**CITY OF LOS ANGELES
INTER-DEPARTMENTAL CORRESPONDENCE**

9010 Reseda Bl.
DOT Case No. 40628

Subject: **TRAFFIC ASSESSMENT FOR THE PROPOSED COMMERCIAL DEVELOPMENT AT 9010 RESEDA BOULEVARD**

SITE PLAN SCHEME #7M

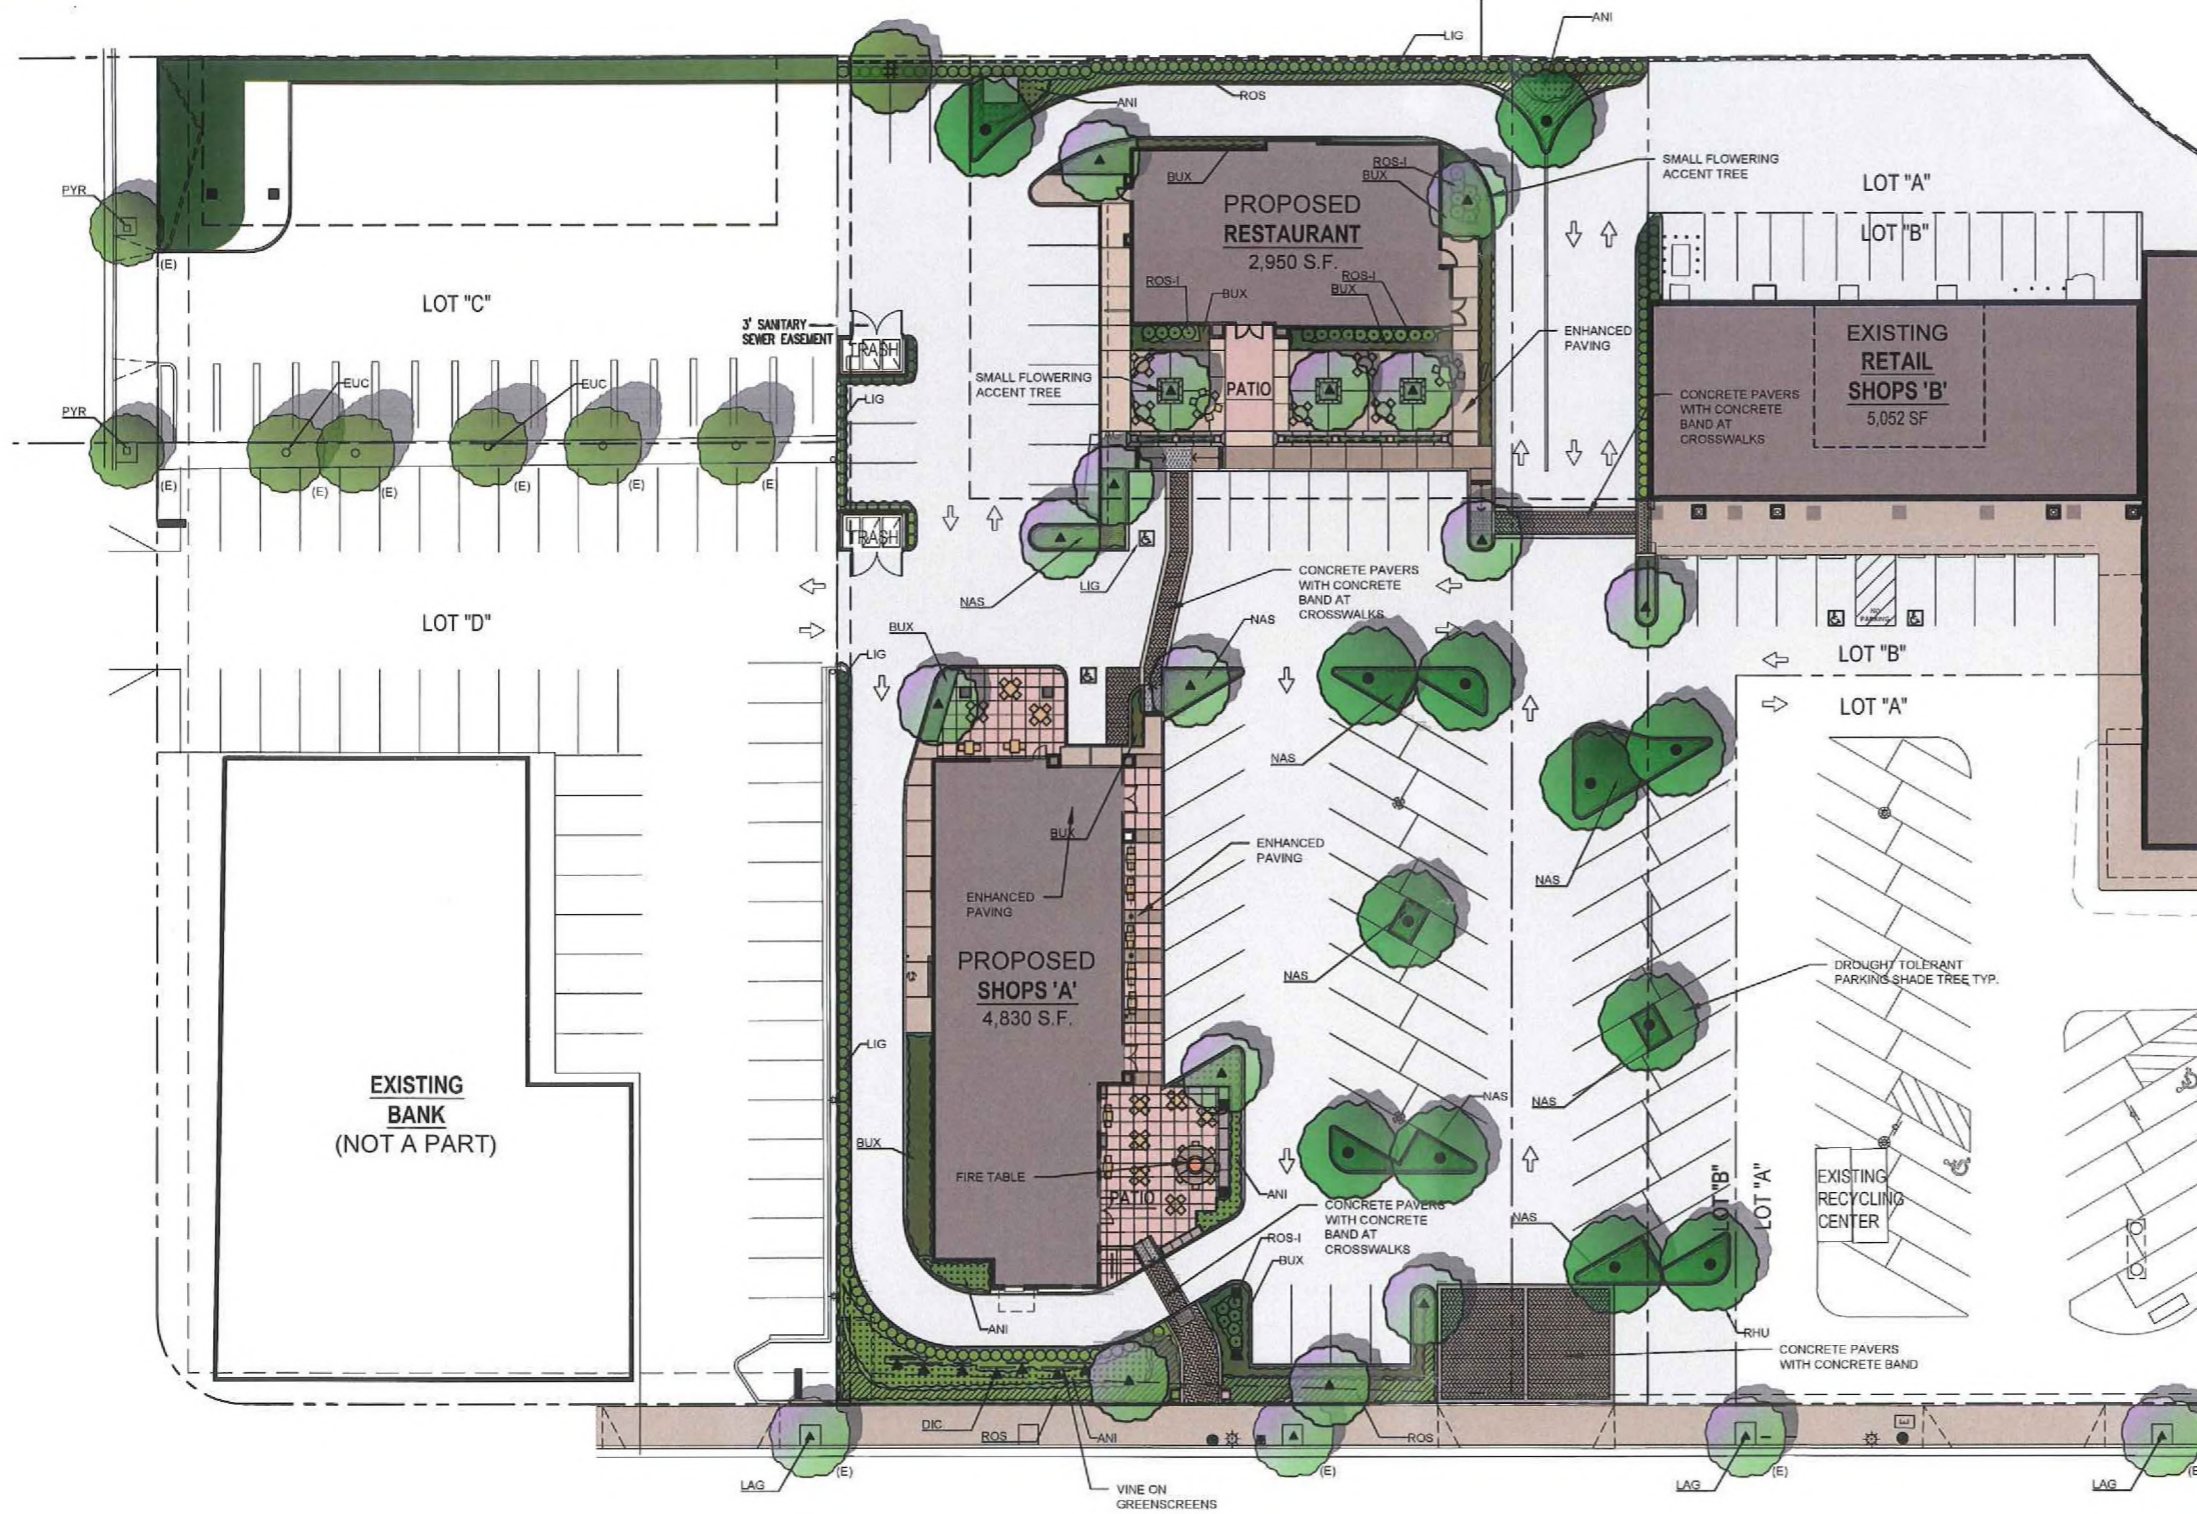
1. The parking layout plan shall include the adjacent roadway curbs and show all driveways as well as any structure or off-site driveway within 25 feet of a project driveway. Driveways should be designed pursuant to BOE Standard Plan S-440-3, with the vehicular-accessible width "W" shown on the plan as 30 feet for two-way access or 16 feet for one-way access. Note that the "W" dimension is less than that of the total curb cut, as it excludes the side slopes.

2. A minimum of 50 feet of full-height curb shall be provided between all driveways.
3. To avoid an influx of vehicles impinging on the public right-of-way, a minimum 20-foot queuing reservoir between the future property line and the first parking stall shall be required at all ingress driveways. This reservoir shall be increased to 40 feet at driveways serving 101 to 300 stalls.

4. The site plan shall show sufficient room along the internal drive aisles to accommodate a peak queuing demand of 15 standard length vehicles in advance of the order board of the fast-food restaurant and 9 standard length vehicles in advance of the order board of the coffee house.

5. To provide internal circulation, all parking areas shall be contiguous and accessible from all other similarly designated parking areas without requiring the use of any public street.

I did review the site plan, and it looks fine to me. So I just need a hard copy to stamp and a check for \$508 payable to LADOT for the driveway permit sign-off fee, and you should be good to go.

STARBUCKS PLAZA

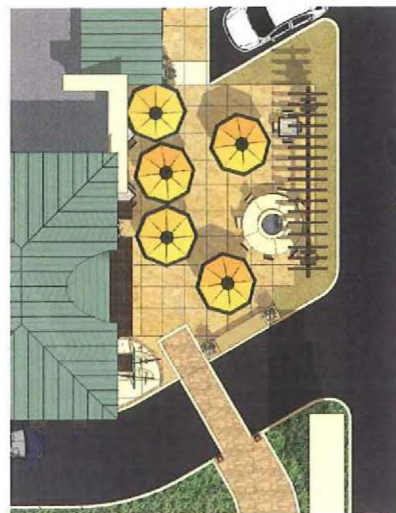
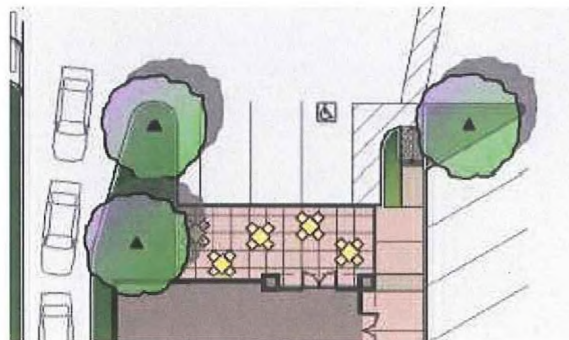
- NEARLY DOUBLE IN SIZE/SEATING AREA
- ENHANCED PAVING MATERIALS
- WIDER PEDESTRIAN ACCESS FROM SIDEWALK
- BIKE RACK
- STONE BENCH SEAT W/ DECORATIVE POTS
- SHADE STRUCTURE WITH STONE COLUMNS
- FIRE TABLE/SEATING
- ACCENT PAVING AT PEDESTRIAN CROSSING
- MONUMENT COLUMNS AT PEDESTRIAN ENTRY TO SITE

PLAZA # 2

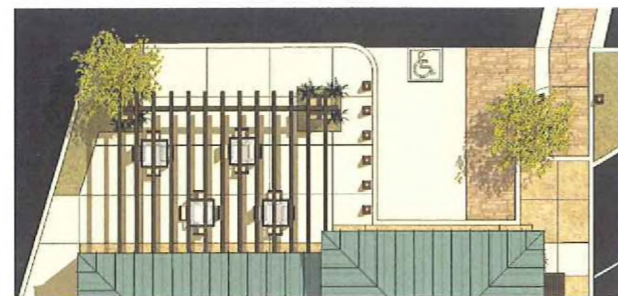
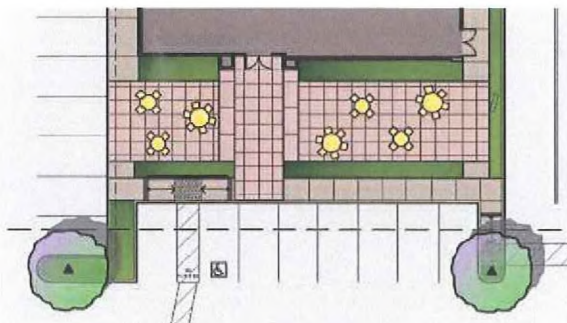
- SHADE TRELLIS WITH STONE COLUMNS
- ACCENT LIGHTING
- BIKE RACK
- ENHANCED PAVING MATERIALS
- ACCENT PAVING AT PEDESTRIAN CROSSING
